Lower Thames Crossing

9.177 Applicant's responses to Interested Parties' post-event submissions at Deadline 6

Planning Inspectorate Scheme Ref: TR010032
Examination Document Ref: TR010032/EXAM/9.177

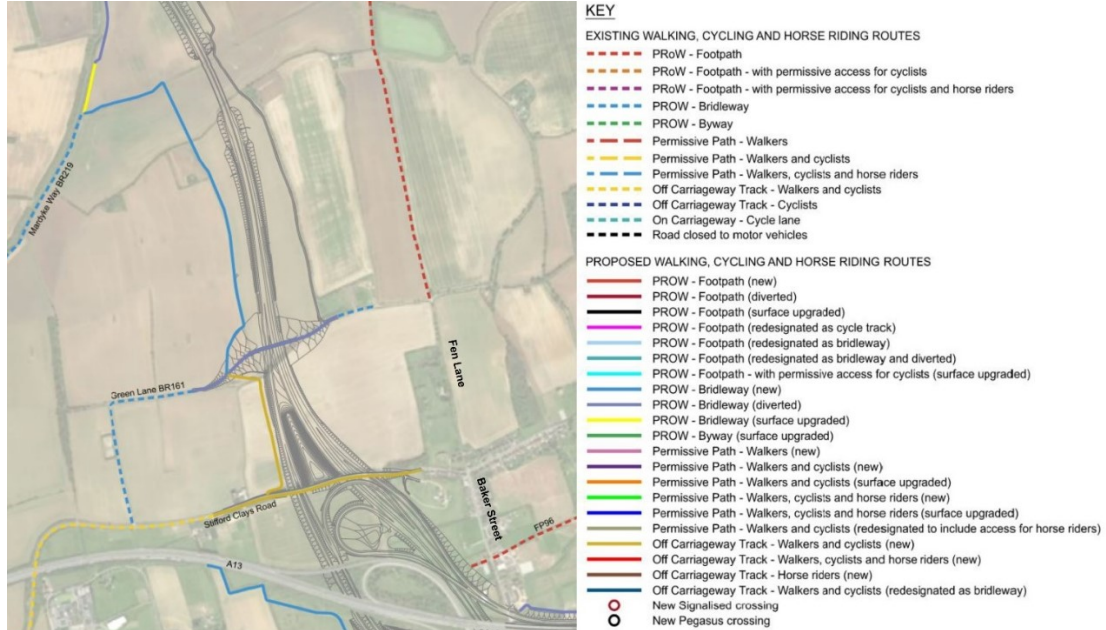
ISH10	Mr Finnis on behalf of the Cole Family	<p>Link to IP's submission: [REP6-205]</p> <p><i>"PROW – Bridleway (new)</i> <i>The Interested Party objects to the proposed new PROW (bridleway) that departs from the Mardyke Way due east and then south to Green Lane as this further opens up their farmland to illegal activities and trespass as demonstrated by the annotated photographs appended to this submission and as presented in oral evidence at ISH10. The Mardyke Way is already used for such purposes and whilst the Interested Party accepts that the</i></p>

Event	Interested Party (IP)	Link to IP's submission / Applicant's response
		<p><i>Mardyke Way will not be downgraded, to extend the accessible area by means of a bridleway will only increase the burden that the Interested Party suffers on a day-to-day basis from these illegal activities.</i></p> <p><i>If this section of new proposed public right of way was restricted to a footpath only, then this would still provide sufficient additional access as required by the Applicant. No "robust measures" suggested by the Applicant will be sufficient to restrict illegal activities caused by motorbikes and quadbikes."</i></p> <p>Applicant's response:</p> <p>This proposed new bridleway connection between the Mardyke Way BR219 to Green Lane BR161 was initially proposed along the alignment of FP90 to the east of the Project alignment. Due to requests from the Cole family this link was moved to the west of the Project alignment in order to reduce the potential impact of unauthorised access on farmland and the Cole family. Linking two bridleways with a footpath as suggested would not provide the connectivity that user groups or the local authority have requested and that the Applicant is required to consider in compliance with the National Policy Statement for National Networks (NPSNN)¹¹.</p> <p>At present the Mardyke Way is accessible from Fen Lane and Harrow Road; the entire western side of Harrow Road borders fields with no ditch, hedge or fence. This creates a 500m long fully accessible edge for people to gain access to farmland and to the Mardyke Way.</p> <p>Figure 12 Northern end of Mardyke Way with dropped curb from the corner of Fen Lane and Harrow Road</p>

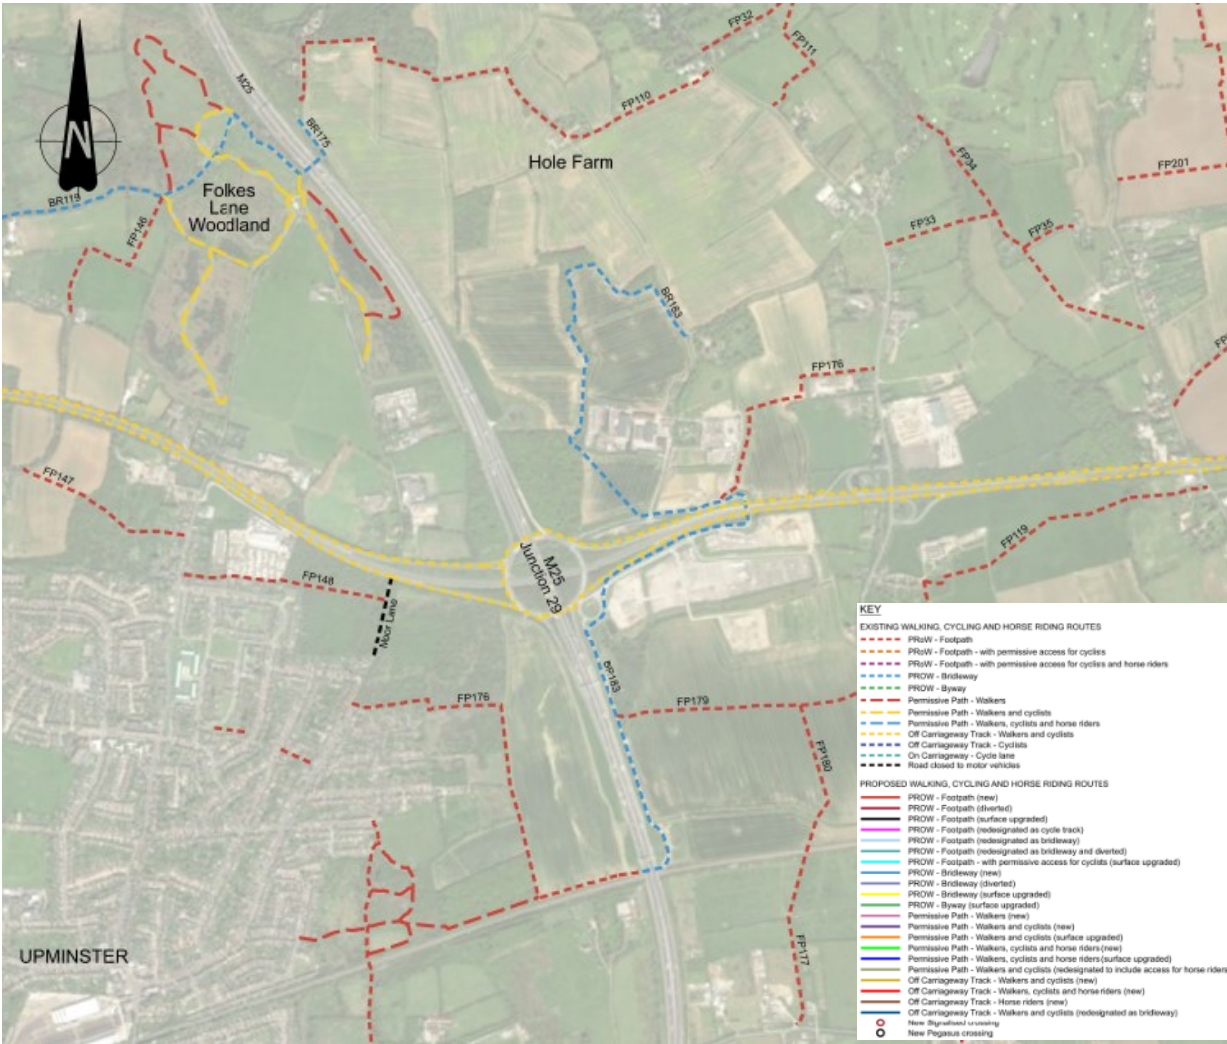
ISH10	Thurrock Council	<p>Link to IP's submission: Point 5.216 in [REP6-166]</p> <p>Applicant's response: Thurrock Council make the case in their Post-Event Submissions for Issue Specific Hearing 10 (ISH10) [REP6-166] that the Applicant is proposing to rely on the Road Investment Strategy (RIS) to address impacts on accessibility in relation to paragraph 5.216 of the National Policy Statement for National Networks (NPSNN)¹³. As set out in the Wider Network Impacts Position Paper [REP6-092], the NPSNN is clear what it means by 'accessibility' in paragraphs 3.19 to 3.22. Accessibility explicitly means accessibility for non-motorised users and for people with mobility impairments. In the same submission, the Applicant set out how it has considered severance across the Project, and how it has proposed mitigation where required to demonstrate compliance with NPSNN paragraph 5.216. The Applicant confirms that where mitigation is required it has been identified and secured within the draft Development Consent Order [REP6-010] or through the other agreements (such as S106 agreements) as set out in the Consents and Agreements Position Statement [REP6-014], and that the Applicant is not relying on funding through the RIS programme to address these impacts.</p>

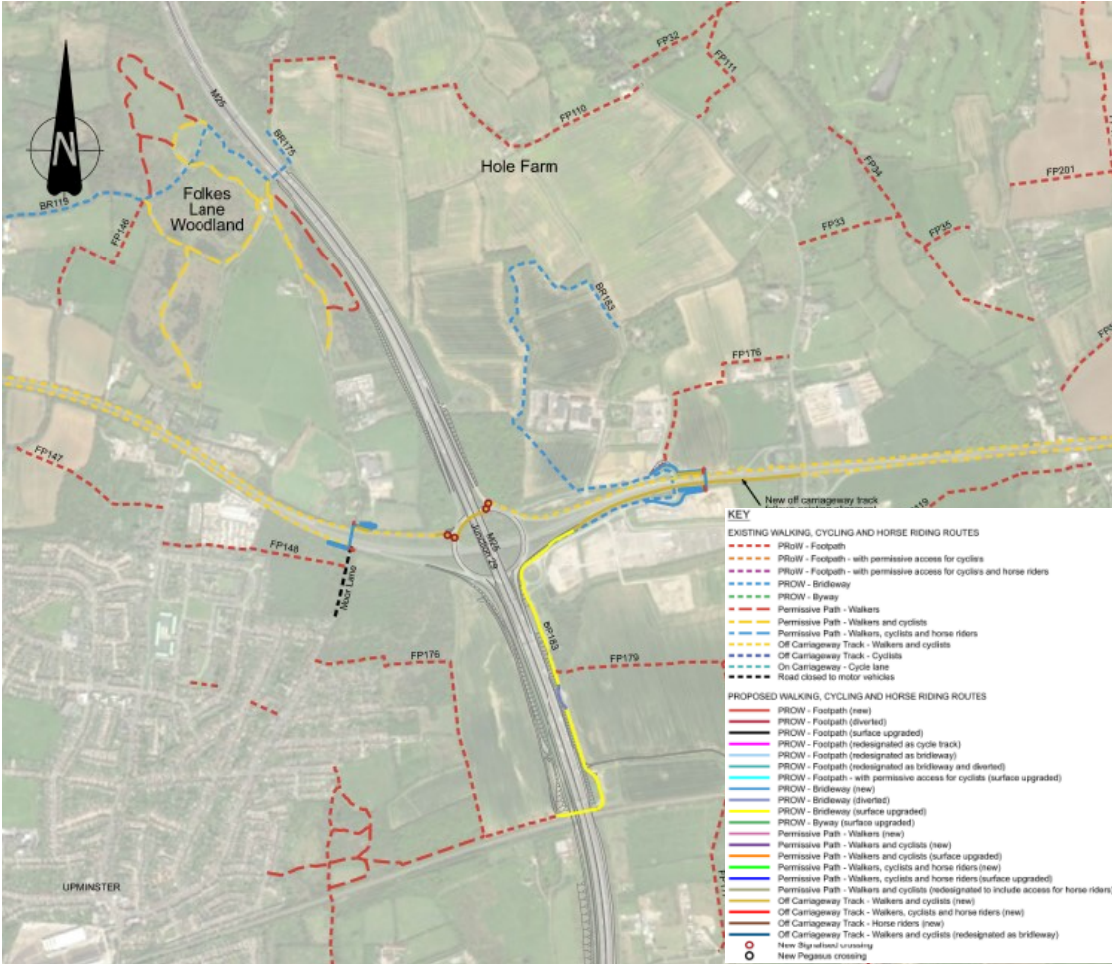
ISH10	Thurrock Council	<p>Link to IP's submission: IP's comments on IEMA guidance in [REP6-166]</p> <p>Applicant's response: The Applicant notes that the Council, in response to Action Point 6 from Issue Specific Hearing 10 (ISH10), in Post Event Submissions for Issue Specific Hearings (ISH8 – ISH10) [REP6-166] make reference to the Institute of Environmental Management and Assessment's (IEMA) publication Environmental Assessment of Traffic and Movement, published in July 2023¹⁴.</p>

Event	Interested Party (IP)	Link to IP's submission / Applicant's response
		<p>From this, the Council suggests that defining unacceptable impacts – in relation to wider network impacts – could be used as a 'starting point'. The Council quotes two criteria – highway links where traffic flows increase by more than 30% (or where the number of heavy goods vehicles increases by 30%) and links of high sensitivity where traffic flows have increased by 10% or more.</p> <p>In general the use of percentage impacts is not typically used in determining the scale of impacts, because such a metric takes no account of the performance of a road before an intervention (in this case the opening of the Project) and can lead to the inclusion of roads with low traffic flows where the increase in traffic associated with the Project is low in absolute terms, but has a corresponding high percentage increase.</p> <p>As the Council notes, these criteria provided by the IEMA are for determining the scale and extent of an environmental assessment. The Applicant notes that the IEMA report states that these criteria '<i>should not be applied to assessments of...road safety and driver delay</i>'.</p> <p>As such the Applicant does not consider that the application of these criteria would help provide a useful definition of an unacceptable impact. The Applicant considers this for the following reasons:</p> <ul style="list-style-type: none"> • The IEMA are clear that these criteria are for the scoping of an environmental assessment. • The IEMA are clear that use of these criteria is not suitable for matters relating to road safety and delay. • It would identify a number of links where the absolute change in flow was low. • It would identify a number of links where the performance of the link would not be of concern post the changes brought about by the Project. • The Applicant has undertaken a number of other assessments, such as that contained within Environmental Statement (ES) Chapter 13: Population and Human Health [APP-151] which considers severance issues caused by the Project. Full signposting to these assessments can be found in ES Appendix 4.4 Traffic and Transport [APP-343].
